Validation of Stream Diversion Design at Iluka Gingin Deposit

Iluka Resources Ltd

2 July 2008

42906853.W0009

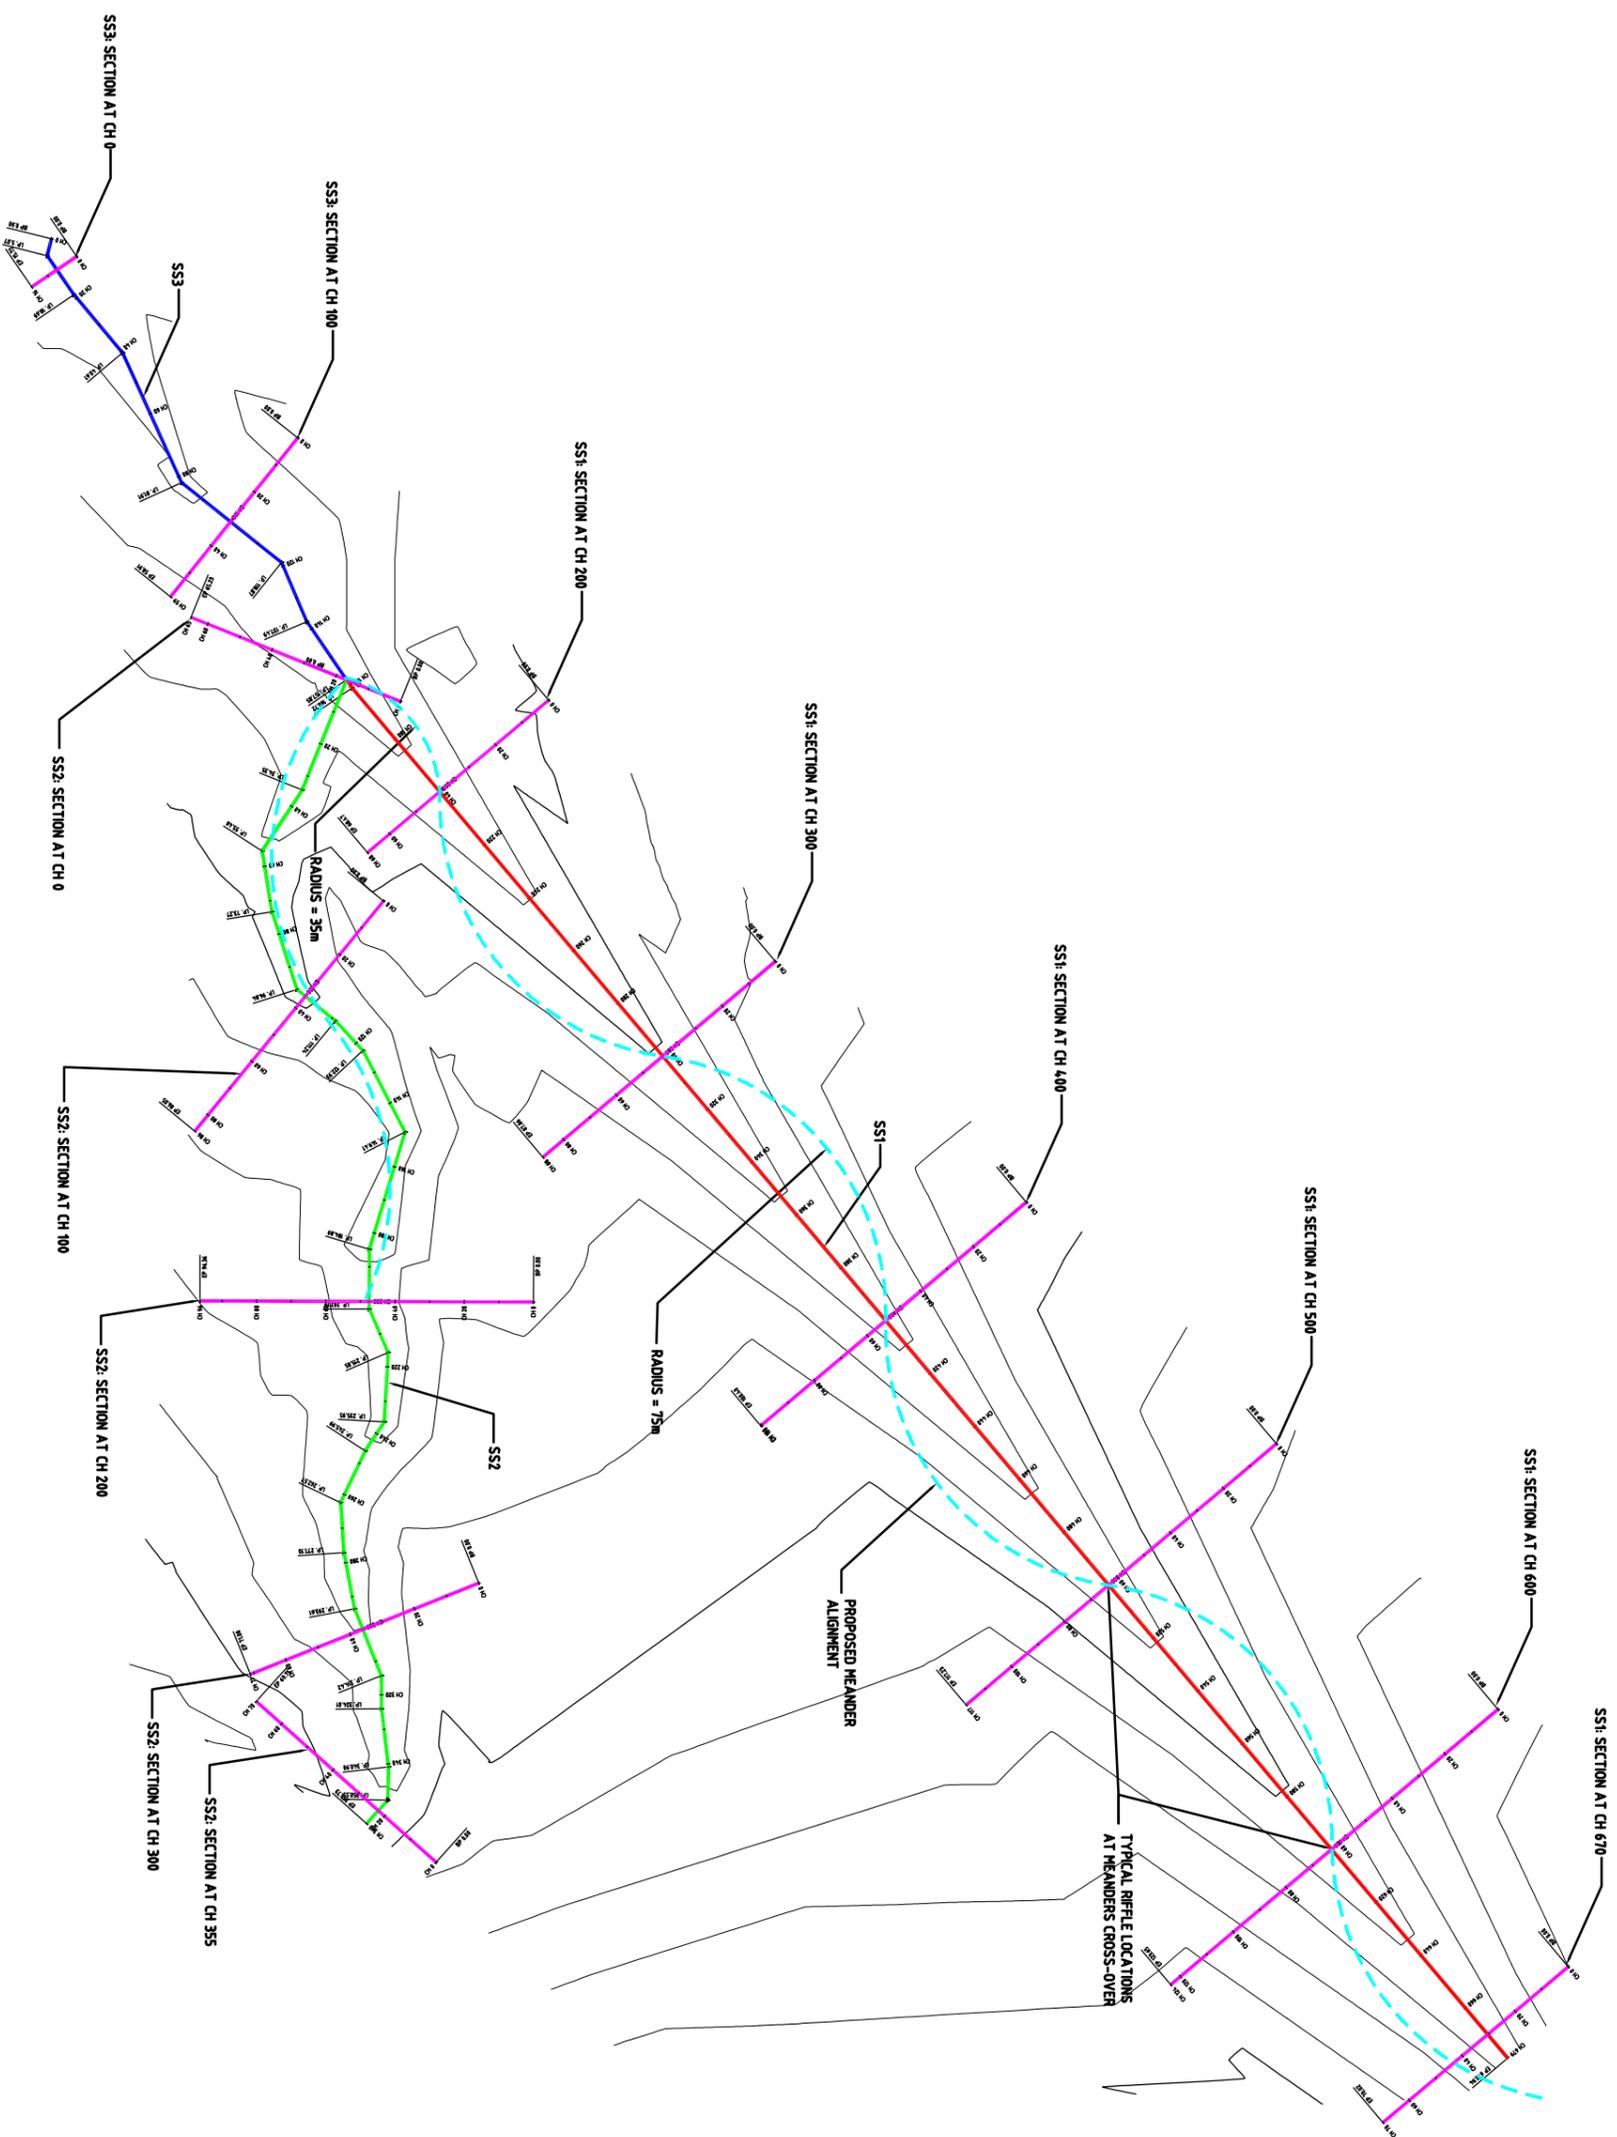
- Meander wave length = 15 X Width of bankfull flow (upper limit) = 50 m
 - Radius of curvature = 2.3 X width of bankfull flow = 7 m
- It is also recommended in the guideline that meanders should be consistent with the flow alignments of similar sized streams in the same district. It has been found that the other tributary, Channel SS2 has a similar setting as SS1 in terms of catchment area, channel slope and landform. Measuring from the survey plan, the meandering in this SS2 channel has the following characteristics (Fig 3-2):

- Meander wave length = 200 m
 - Radius of curvature = 75 m
- It is suggested to adopt the same meandering features of SS2, as shown in Fig 3-2.

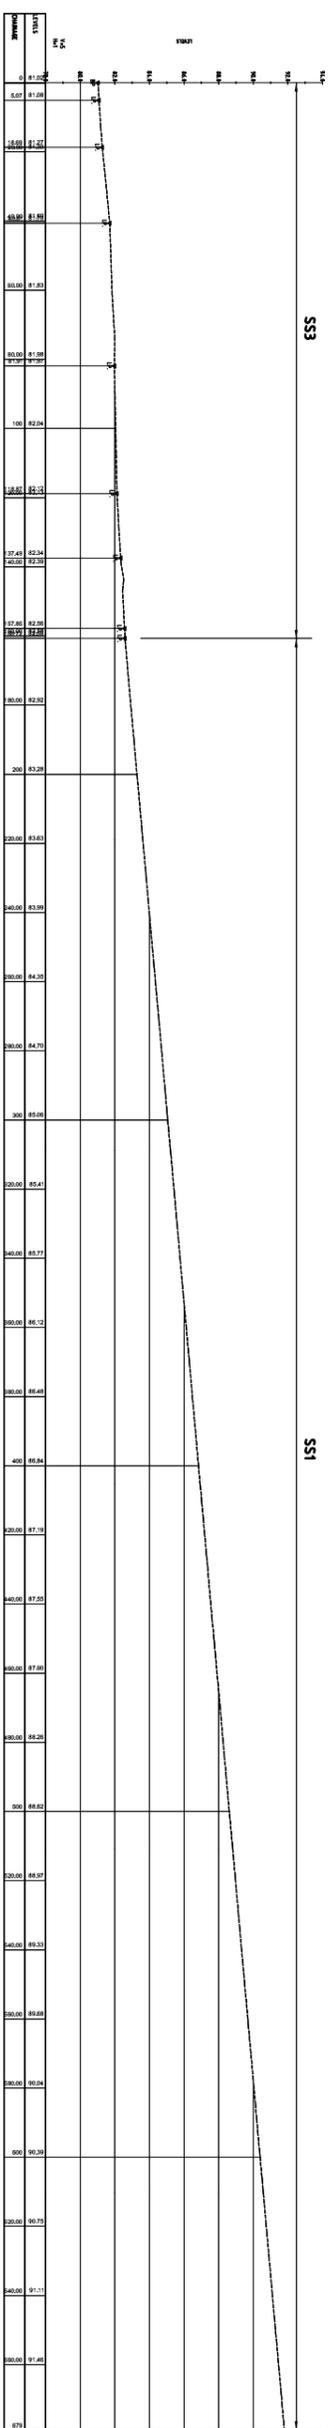
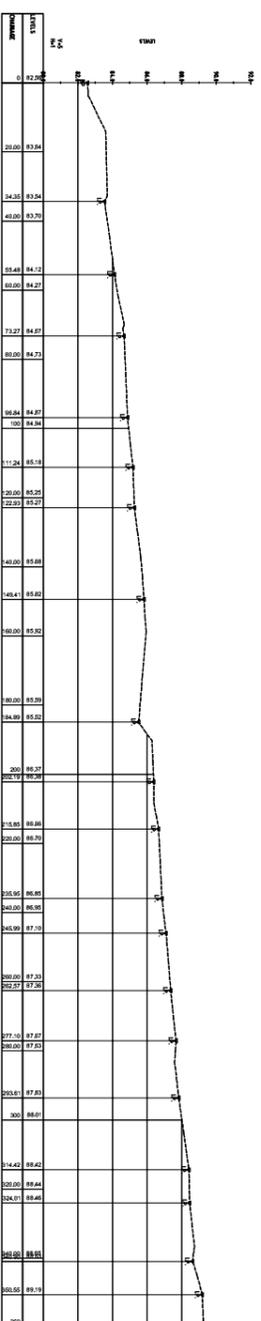
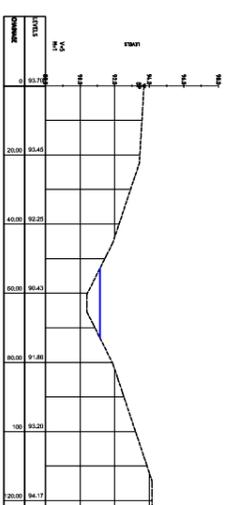
The two tributaries SS1 and SS2 have comparable characteristics in terms of catchment area, stream length, channel slope and peak discharge rates. Therefore it is suggested to adopt the same design for both channels. The design discharge rate has been rounded up to 6 m³/s. With the designed side slope of 1:2 and a bottom width of 5 m, the flow depth will be 0.75 m deep at the design discharge rate. This will be well contained in the design channel except at Ch. 355 m of channel SS2, where it will spill the bank. Some bunding or deepening/widening may be necessary at this location.

In general, the original design for the South Stream is adequate, except at Ch. 355 in channel SS2 which may need some bunding to contain the 1:20 yr ARI flow.

- The design sections for the South Stream are generally adequate, except at Ch. 355 in channel SS2 which may need some bunding, or deepened/widened to contain the 1:20 yr ARI flow.
- The triangular design section for the North Stream can not contain the 1:20 yr ARI flow. An alternative trapezoidal design section with a 5 m bottom width is recommended.

Drawing Number: Figure 3.4

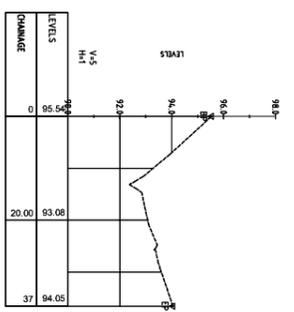
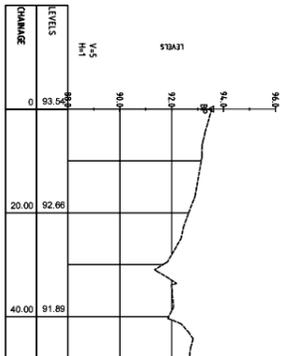
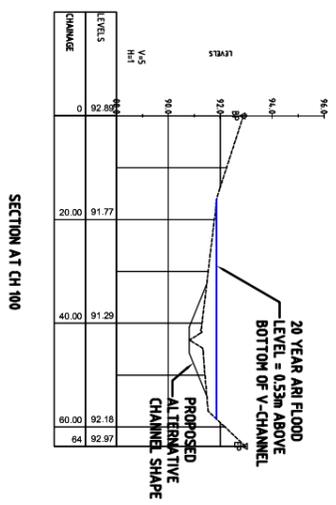
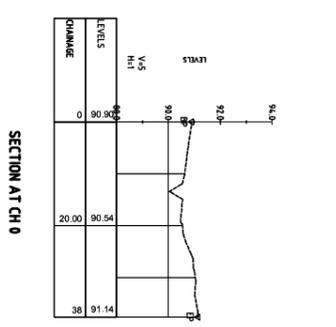
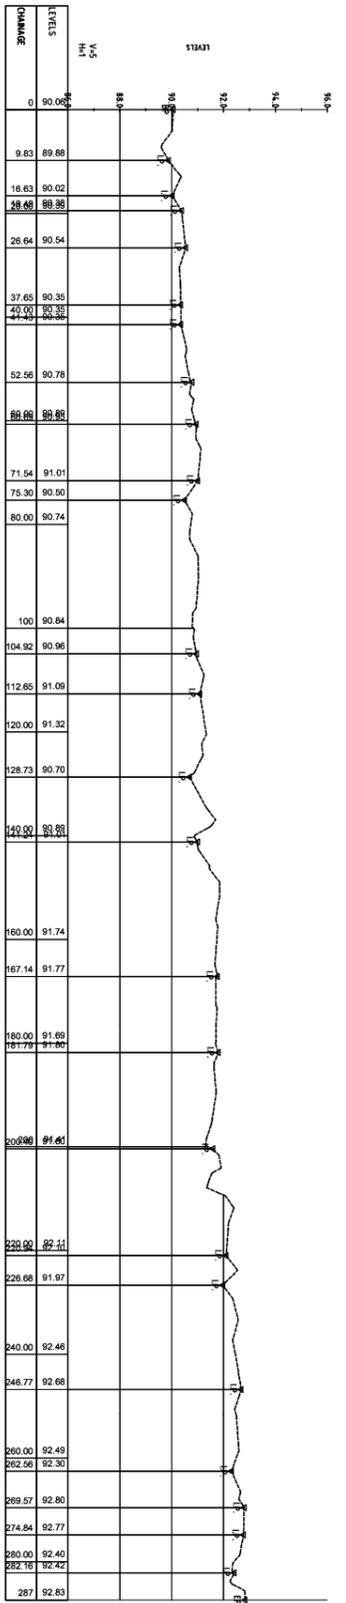
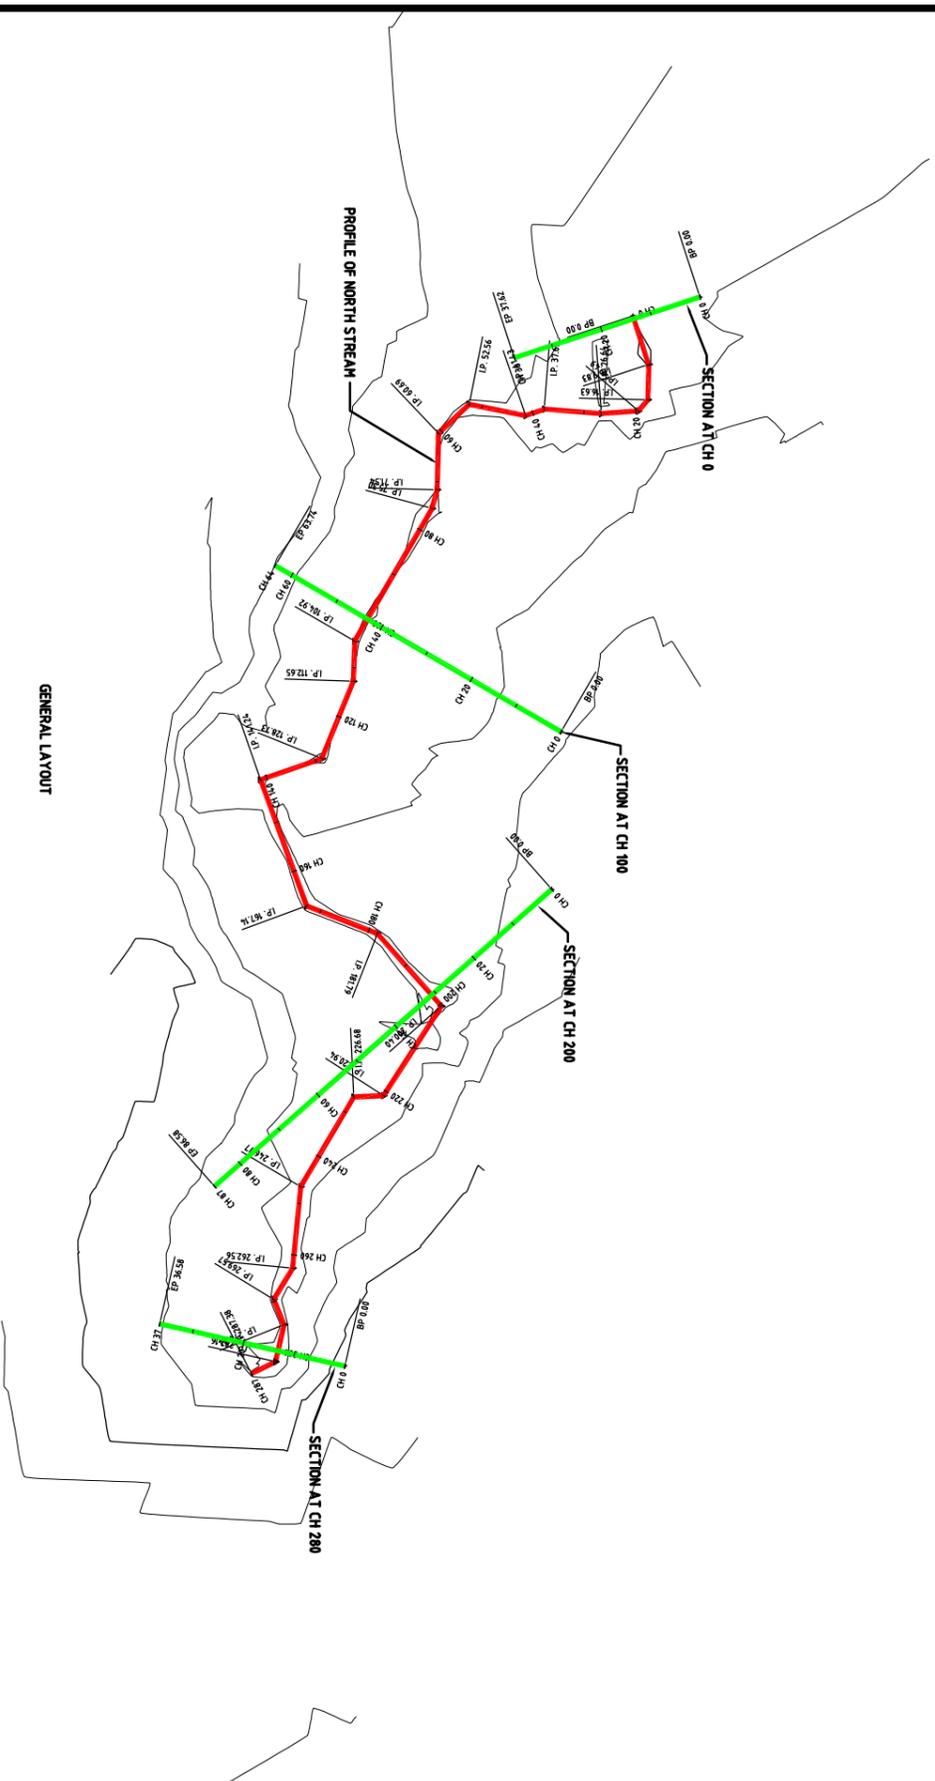
It seems from the result that the triangular low-flow section is insufficient for the 1:20 yr ARI peak discharge of 11 m³/s (rounded up to 12 m³/s for design purpose). The flood flow will inundate to the adjacent flood plain. The flood flow width will be approximately 60 m wide based on the typical section at Ch. 100m. The flow area required is about double compared to a case where the flood flow is contained in the stream channel. This is due to the much longer wetted perimeter of the flow section on the flat flood plain.

To avoid this low-efficiency flood flow regime, it is recommended to have a larger trapezoidal section with a 5 m bottom width as an alternative to the triangular section in the original design (see cross section at Ch. 100 in Figure 3-4). The flow characteristics of this alternative trapezoidal section are shown in the last column of the Table 3-5.
